The Stamford on Kent Building

**Barangaroo Concept Plan Modification
MP06_0162 Mod 4**

14 Sept 2010

**List of Contents for Response to Barangaroo Concept Plan Modification
MP06_0162 Mod 4**

BLOCK 4 DESIGN PRINCIPLES

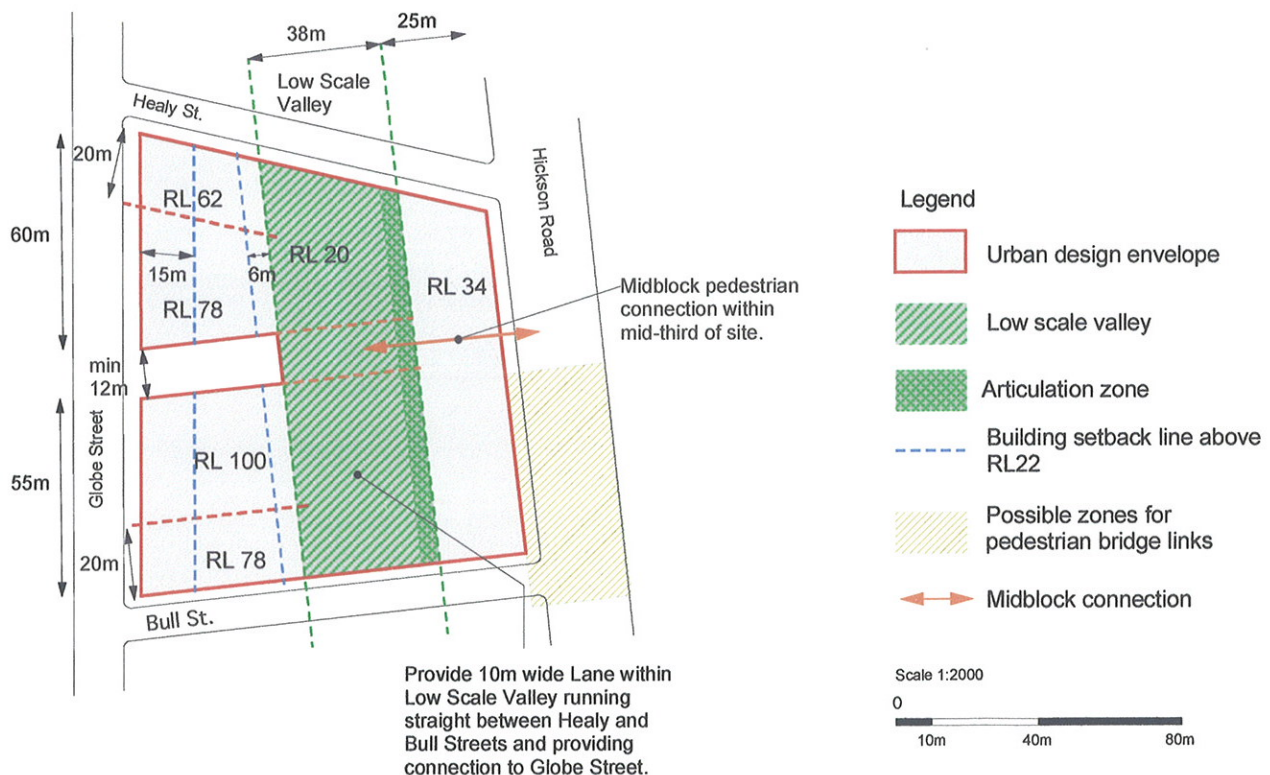
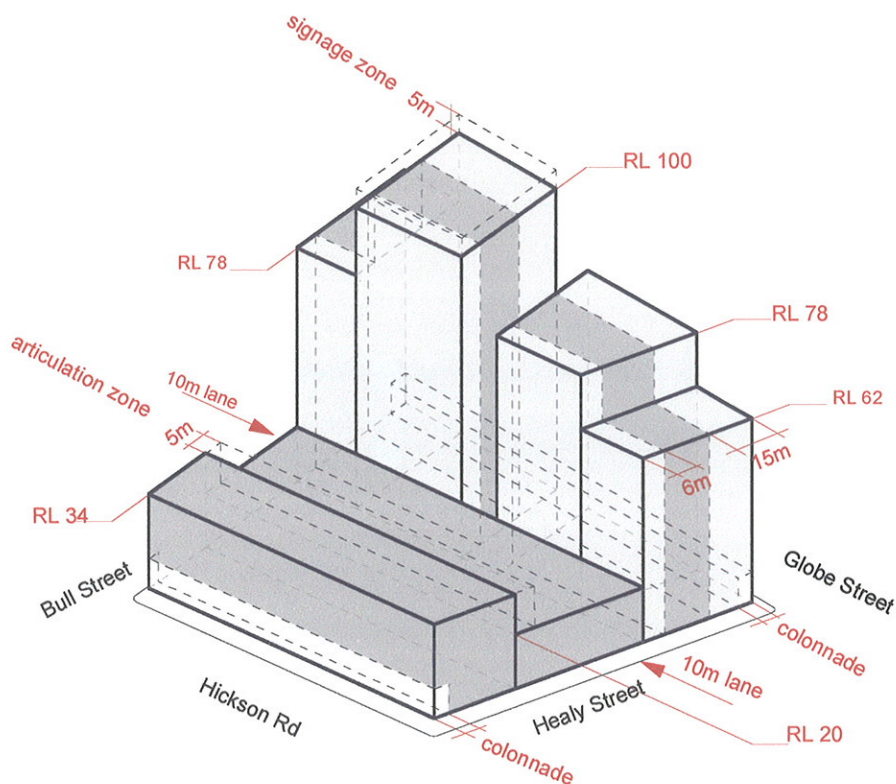
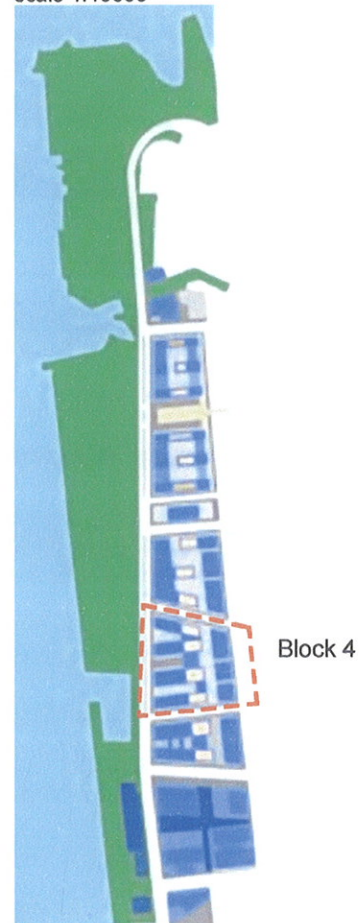
Again we are faced with the proposition of overshadowing height increases with figures illustrating the proposed Urban Design controls (for Block 4 pages 74 to 79). In other parts of these documents " the Approval Seeks to increase Block 4 from RL 100 to a maximum of RL 175 in Block 4B (an increase of 75m) noting the approved Block 4 has been split into 3 separate Blocks"

The earlier Consolidated Concept Plan, e.g. the attached figures A1 And A2 Block 4 design requirements show clearly that the maximum height on Hickson Road as RL34, a gap and the RL100 buildings facing Globe St. It appears that this newly proposed Block 4B is planned to be located in this gap and both much too close to Hickson road and not a height increase of 75m but more like an increase of 141m.

Figure B1 Kent Street residences in relationship to Barangaroo South proposal

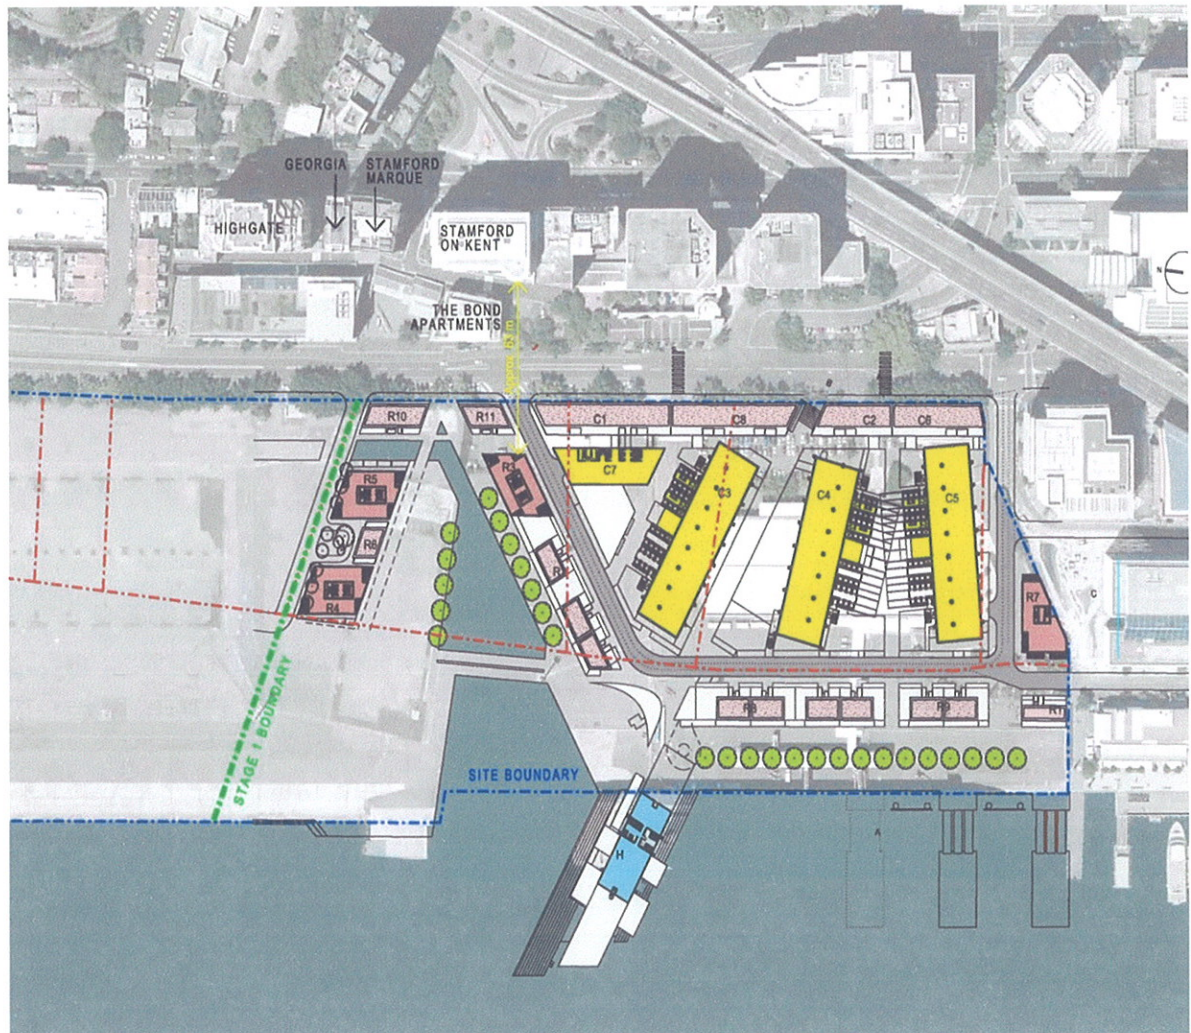
1.The location of the Stamford on Kent in relationship to the Barangaroo South proposal and its high rise buildings. This is illustrated in the Figure B1.

As the figure shows Building R3 is due west and Buildings R5 and R6 are North West of the Stamford on Kent. These buildings exceed the RL of the Stamford on Kent by 75m and 63m respectively, clearly blocking solar access.

Figure B2 SOK Shading Impacts Due to New Lend Lease proposal

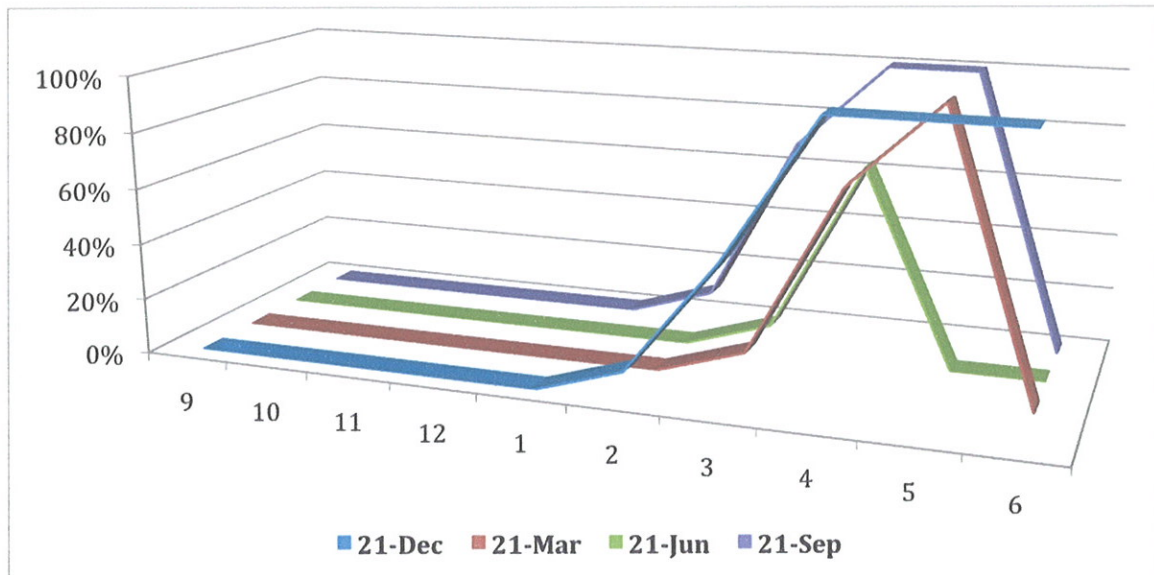
2. The shadow diagrams which show the impact of the requested modification in Yellow are illustrated in the Figure B 2

Our objection to both the size and height of the proposed Barangaroo residences in terms of the enormous loss of solar access for the Stamford on Kent residential building is justified by examination of the information Lend Lease provided. Further the Shadow diagrams appear to also show that the November Lend Lease proposal has a far less impact on the loss as R3 is not in that location and R5 & R6 are much lower.

Figure N1

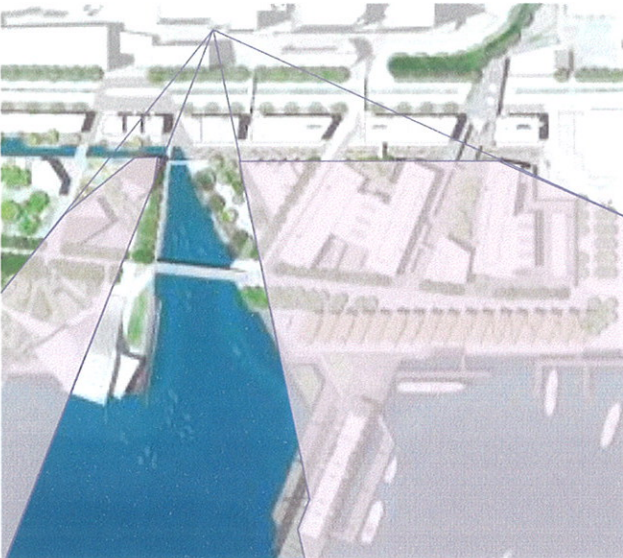
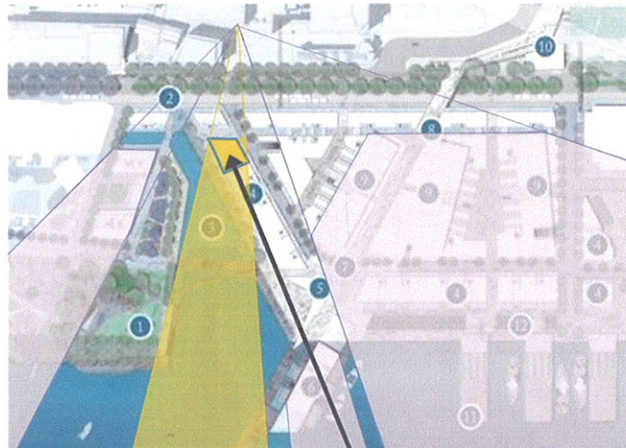
Loss of view corridors

It is quite evident that from this figure N1 and the other appended photomontages that the Stamford on Kent's view corridors have been both seriously impacted and disadvantaged by this latest Concept plan Modification. The Lend Lease documents attempt to minimize the situation.

Figure N2 Lend Lease Photo Montage showing impacted views

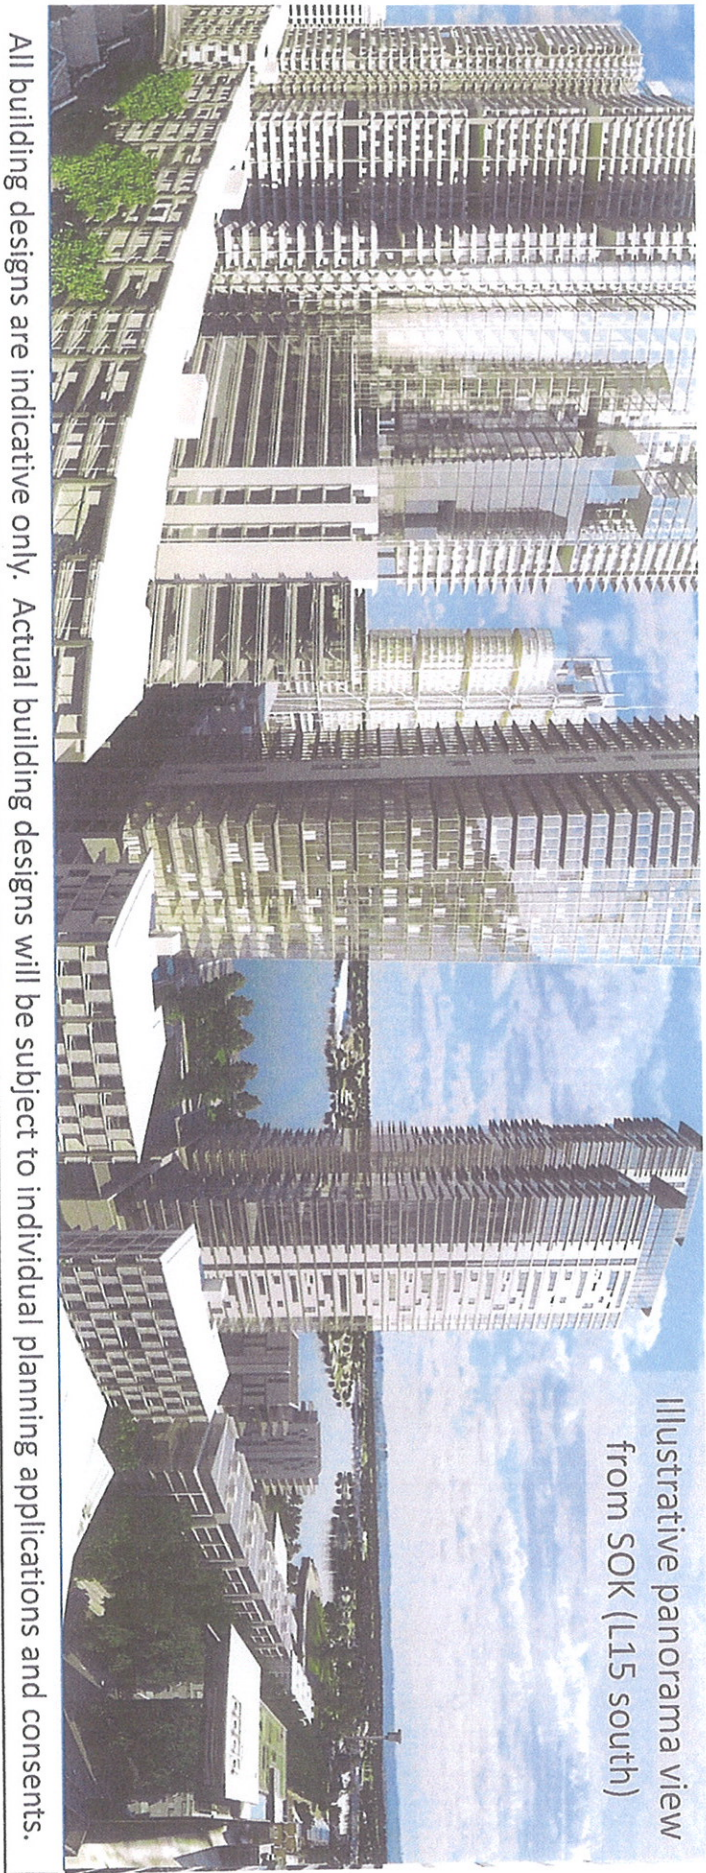
The proposed location of R3 is the cause of the problem and its relocation further South-West could both improve the view corridors and alleviate considerable residents concerns.

Figure N6 Lend Lease proposed Model Note the R3 impact on SOK

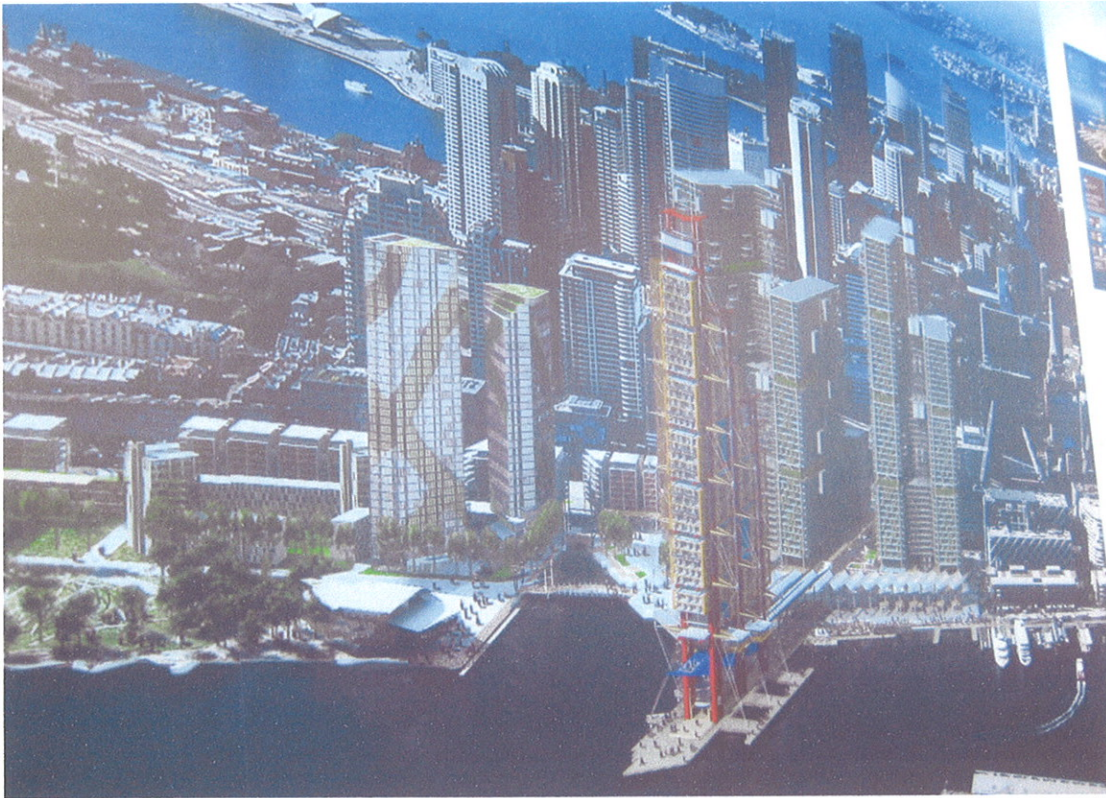
Figure N5 Lend Lease November Model Note SOK broader view

Environmental Assessment Report Site Amendment 6.0 page 84/102

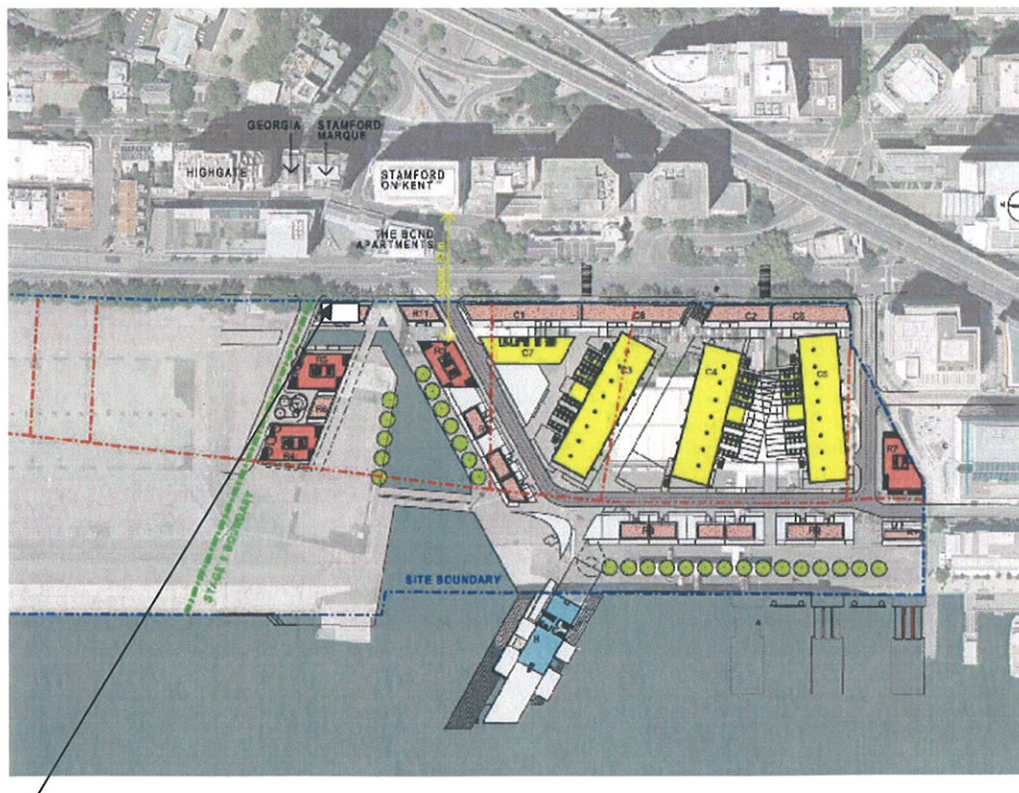
Increase the maximum permissible height in Barangaroo South blocks

KSRG was opposed to heights on original plan and is opposed to new heights

R10 is coloured in white. This area should be a plaza to match the Bond Plaza across the road. It would integrate Barangaroo and Hickson Rd buildings and provide a meeting place for the people using the cultural centre

Fig. 1: Selected views of Lend Lease Barrangaroo Stage 1 Scheme – Sydney City Model

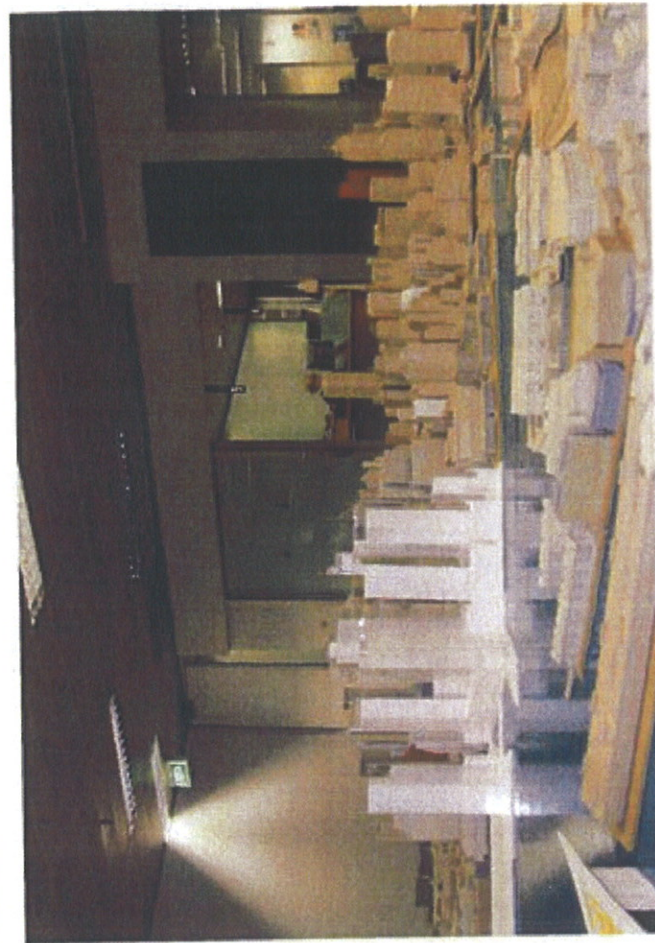
- Deletion of the proviso 'indicative' from any building envelopes drawings.
- (2) The perspective views accompanying the application are misleading due to wide-angle viewpoints which distort the building form. This is evidently apparent through comparison of the perspectives with photographs of the model prepared by Sydney City Council. **See figure 1.**
